Conceptual Review Agenda

Schedule for 01/28/13 to 01/28/13

Monday, January 28, 2013

429 S Whitcomb St Carriage House & Home Addition

PLOT PLAN 1" = 20'
 46 UNIT APARTMENT PROJECT - 80 PARKING SPACES
 24-1-BDRM UNITS # 22-2-BDRM UNITS
 HARDER BLD'G & DEV. - PAUL HARDER - 970-539-0825

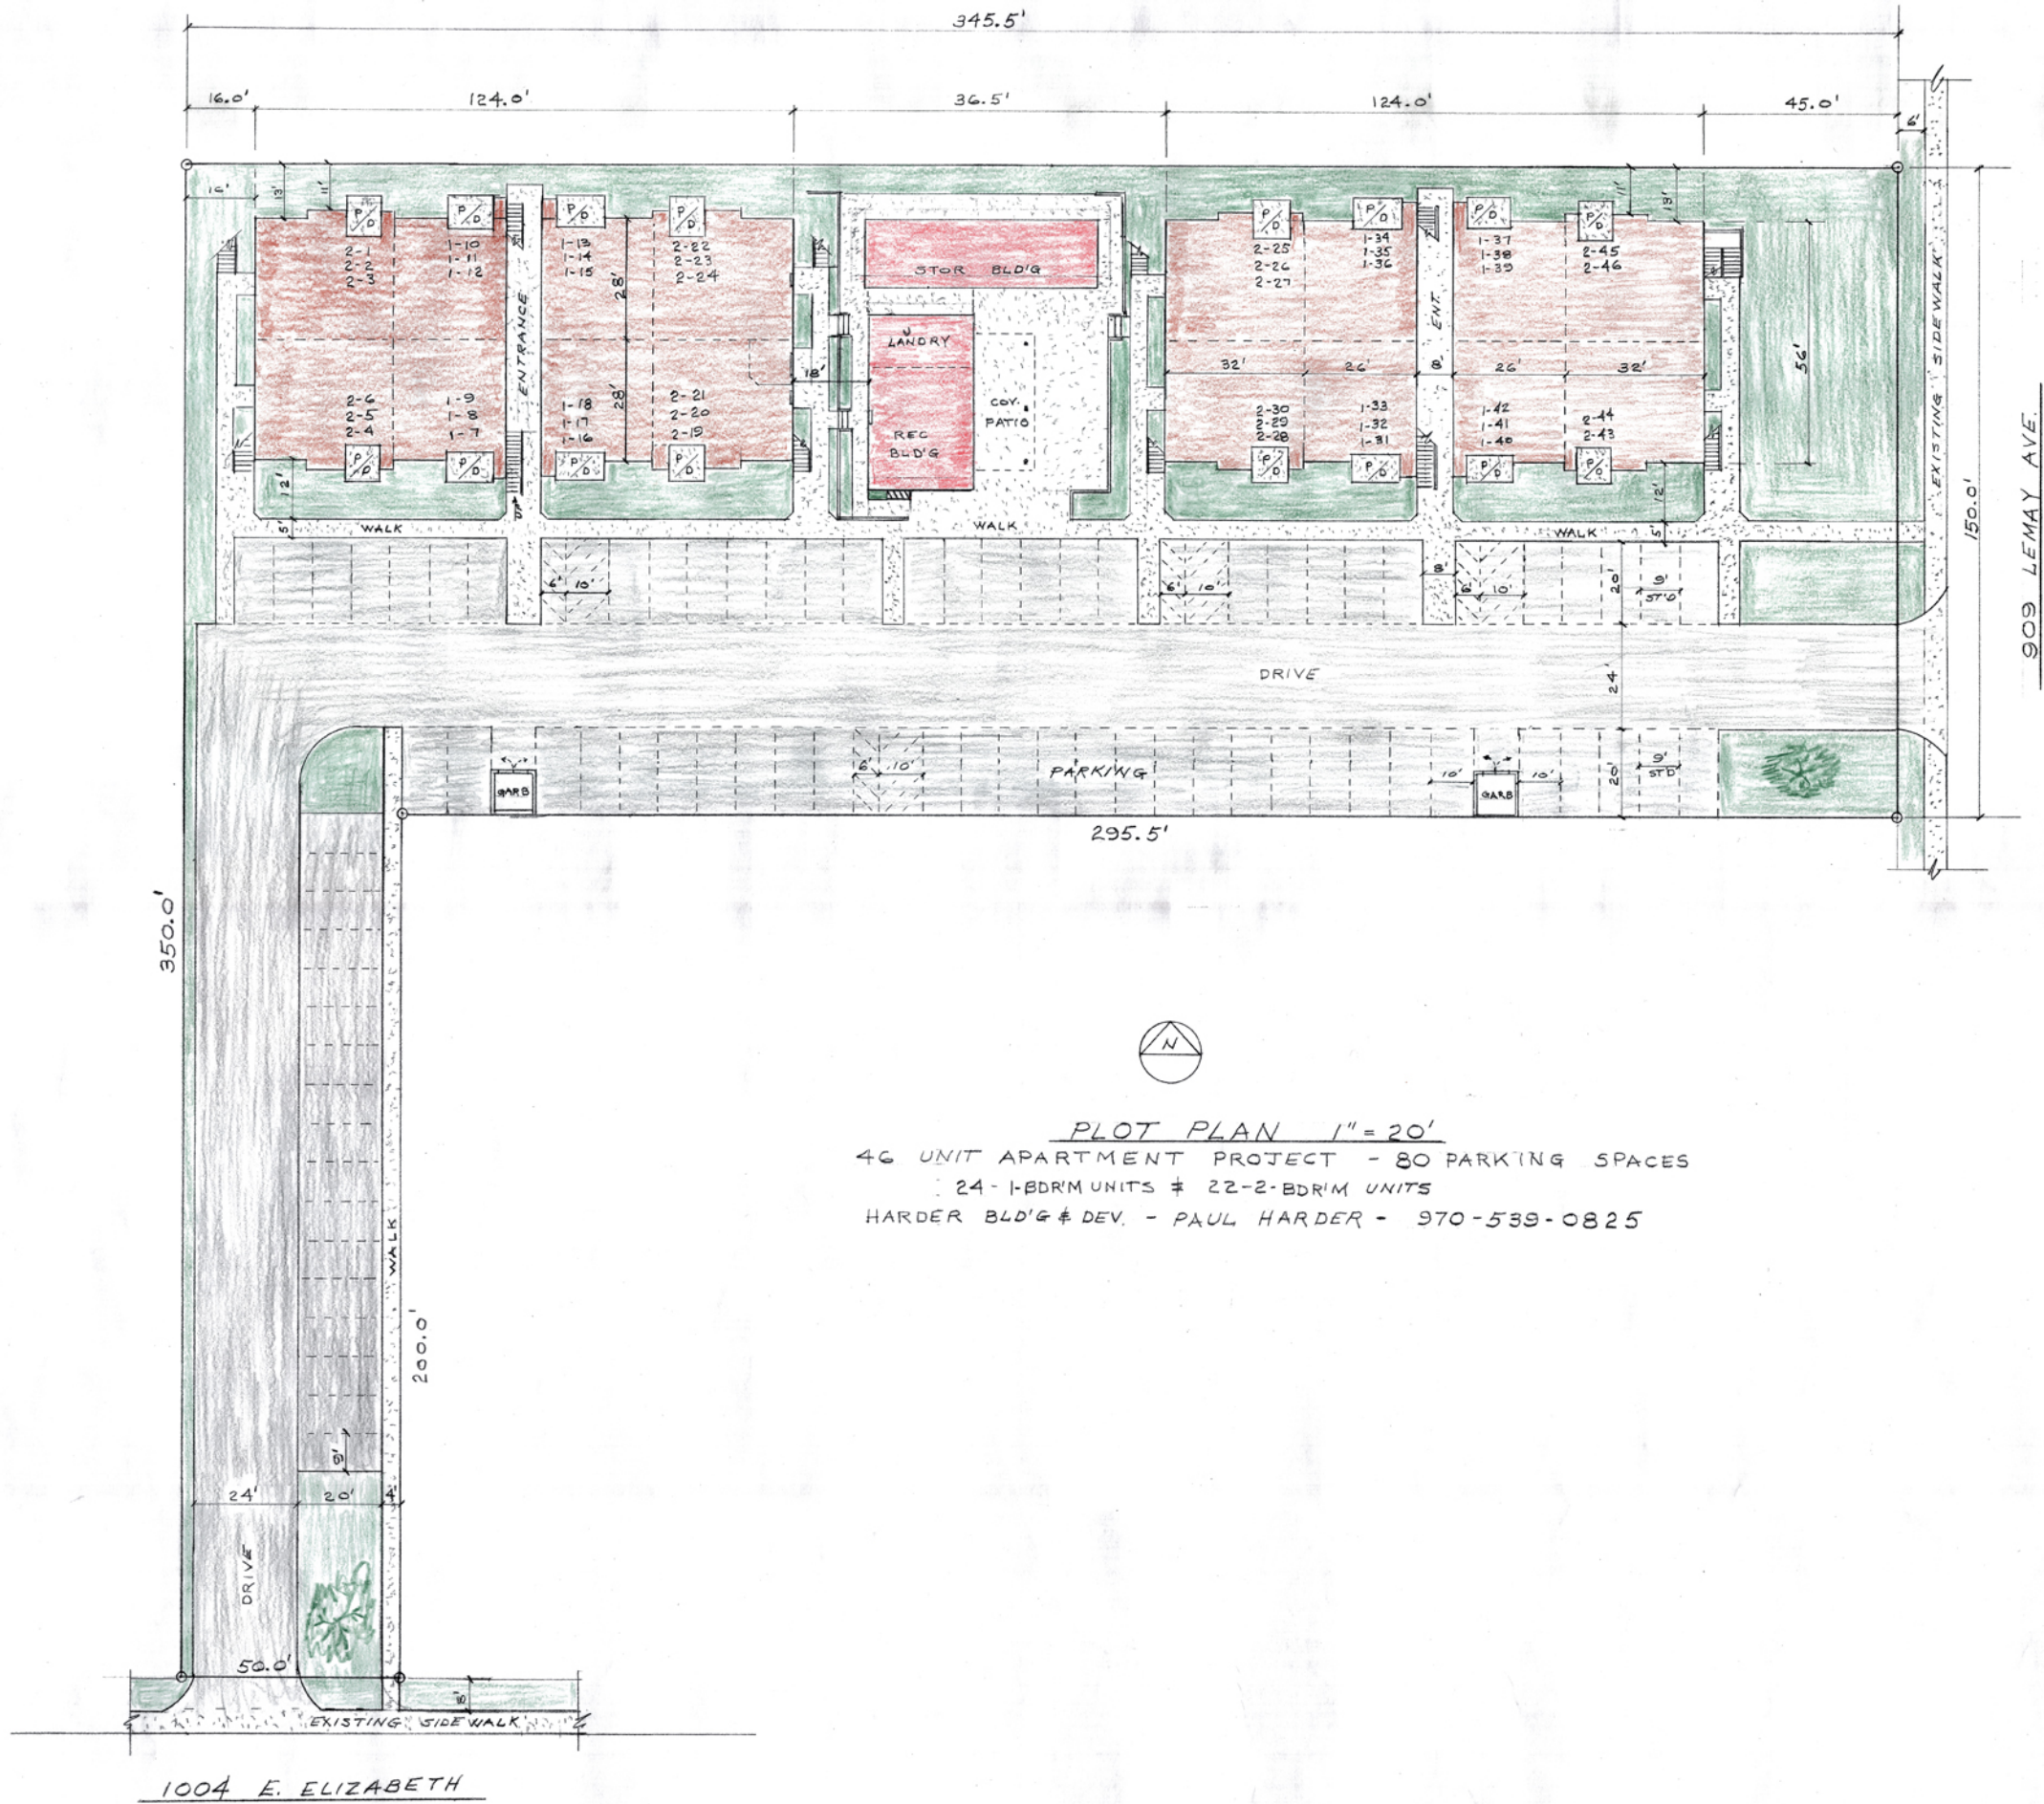
7. Sidewalk will need to be detached and 6 feet in width along Lemay Avenue to meet arterial standards. Further conversations will need to be had depending on a site specific plan on whether or not sidewalk will need to be detached along Elizabeth Street.
